February 24, 2016

Re: Response Action Plan Addendum Former Kop-Flex Facility Site, Hanover, Anne Arundel County, Maryland Brownfield Master Inventory Number MD0286

Attachment A – Revised Sheet 3 of Engineering Design Drawings

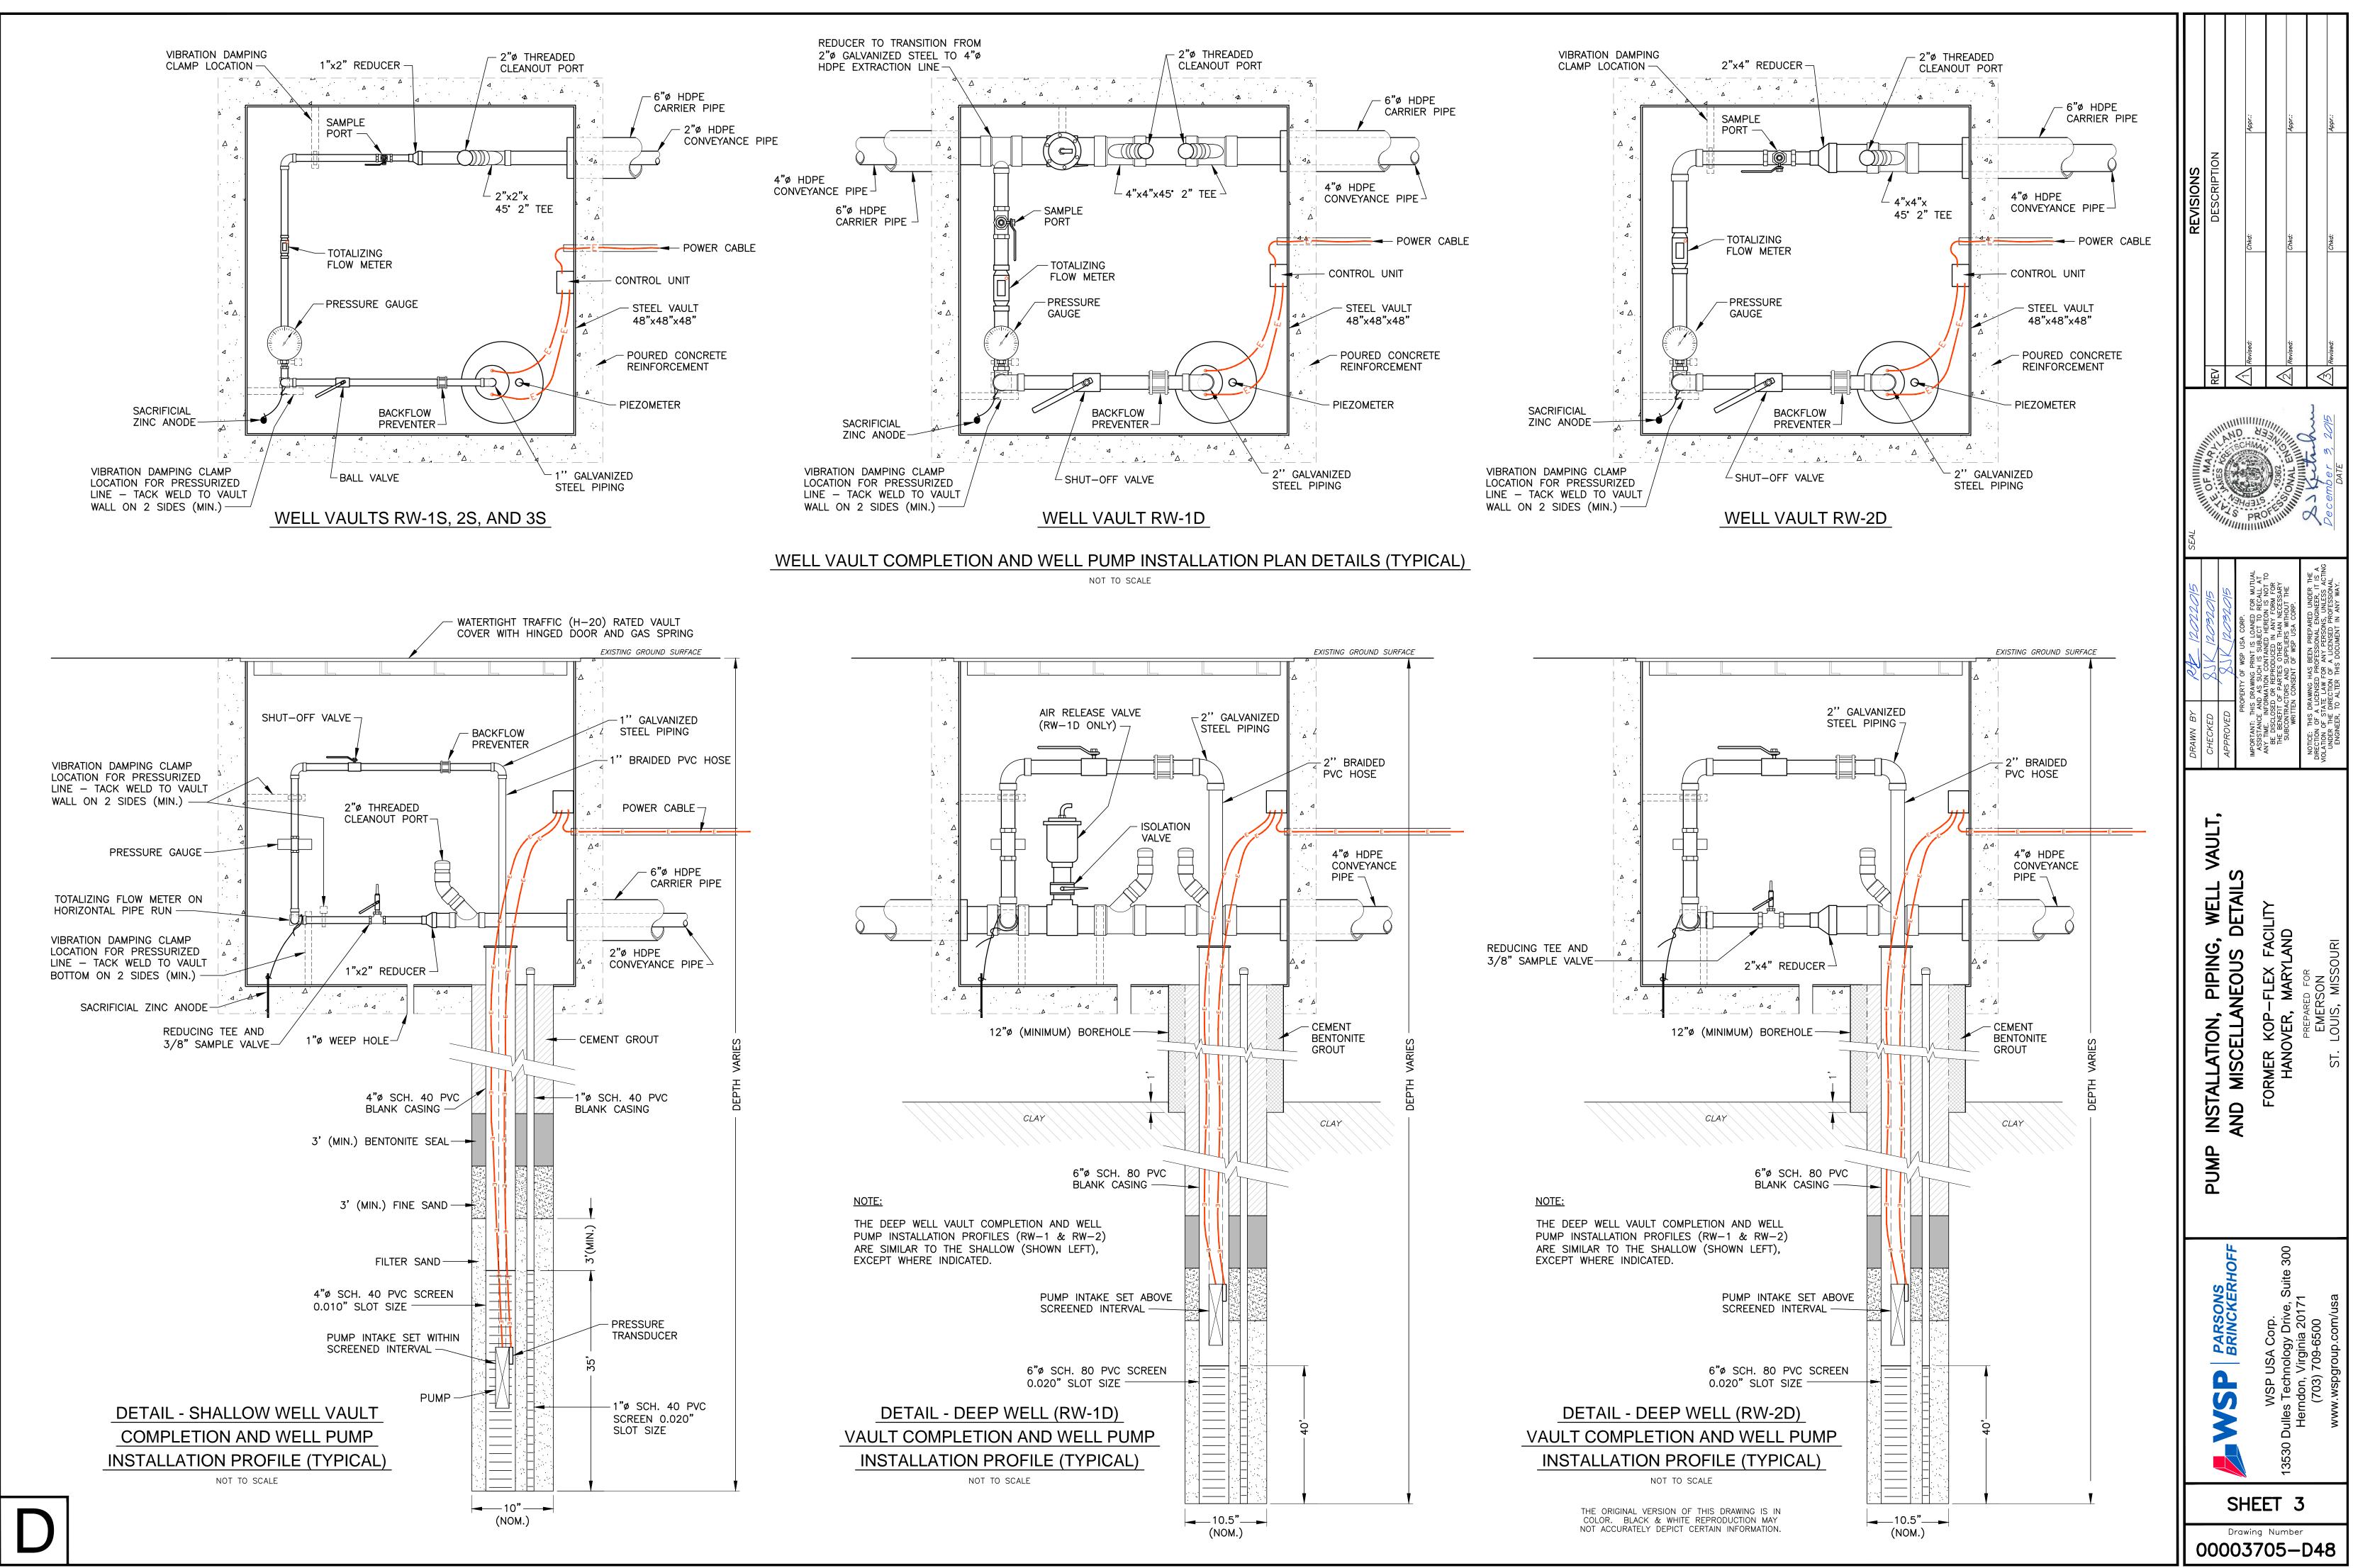
Given the overall similarity in water quality and absence of groundwater impacts in the shallow hydrogeologic unit, the placement of a permanent outer casing during the installation of the deep extraction wells to seal off the unconfined and confined zones is not considered necessary. The proposed alternative deep well construction will involve the setting of a temporary outer casing in the clayey aquitard to seal off the shallow groundwater zone during borehole advancement into the confined portion of the aquifer and subsequent well installation. Using this approach, the steps in the drilling and installation are outlined below.

- Well borehole is advanced by the coring/casing system until encountering the clayey aquitard. The 4-inch diameter core barrel is removed leaving the outer (10.5-inch diameter) drill casing seated into the confining layer.

- A larger (12-inch diameter) over-ride casing is then advanced around the 10.5-inch casing to the same or slightly greater depth, and serves as the temporary surface casing for the borehole.

- After setting of the 12-inch temporary surface casing, the seal between the casing and clayey aquitard deposits will be tested to ensure it is effective before resuming the drilling activities. Test method will involve filling the inside of the temporary casing with water and monitoring the water level over a short time period.

- Upon determination of an adequate seal with the 12-inch temporary surface casing, continue with the borehole installation to the target depth using the coring/casing system inside of the 12-inch surface casing.

- Construction of the 6-inch extraction well and co-located 1-inch piezometer, including placement of the annular fill materials (filter sand, bentonite seal and grout) occurs inside of the 10.5-inch drill casing.

- During addition of the grout seal, the 10.5-inch drill casing is removed first followed by removal of the 12-inch temporary surface casing, leaving a grout column that has been "knitted" with the borehole wall.

The alternate design for the deep wells is consistent with the Code of Maryland Administrative Regulations (COMAR), 26.04.04 – Well Construction.

A revised copy of Sheet 3 of the engineering drawing package showing the proposed construction details for deep extraction wells RW-1D and RW-2D is provided in Attachment A. Other than this design modification, the deep extraction wells will be constructed in accordance with the information provided in the MDE-approved RAP.
